## Product Change Notification (PCN) – **CORRECTED VERSION**

Date: 04.05.2020  
No.: 02-2019

### Panasonic Pyroelectric Infrared Sensors - PaPIRs

#### Notification of product change

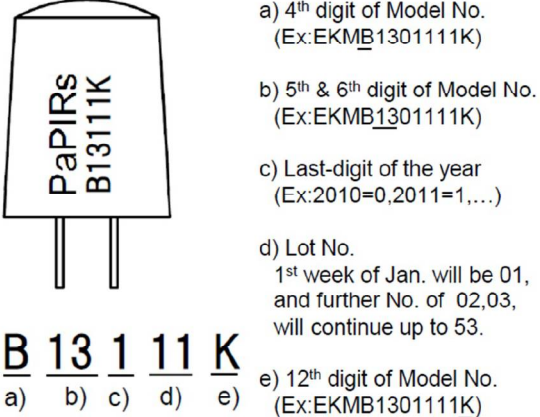
The labelling of the PaPIRs on the polyethylene lens will change.

New date code labelling	Part numbers	Marking
 <p>a) The Marking as the table on the right.            b) Last-digit of the year  (Ex:2019=9,2020=0,...)            c) Lot No.            1<sup>st</sup> week of Jan. will be 01, and further No. up to 53</p> <p><u>D</u> <u>9</u> <u>45</u>            a) b) c)</p> <p><b>Fig. 1: Date code label of the Low Profile Type. This is valid for all types except the Standard Detection Type.</b></p>	EKMB11□□11□	D
	EKMB12□□11□	E
	EKMB13□□11□K	H
	EKMB43□□11□K	I
	EKMC16□□11□	J
	EKMC26□□11□K	K
	EKMC46□□11□K	L
	EKMC76□□11□K	N
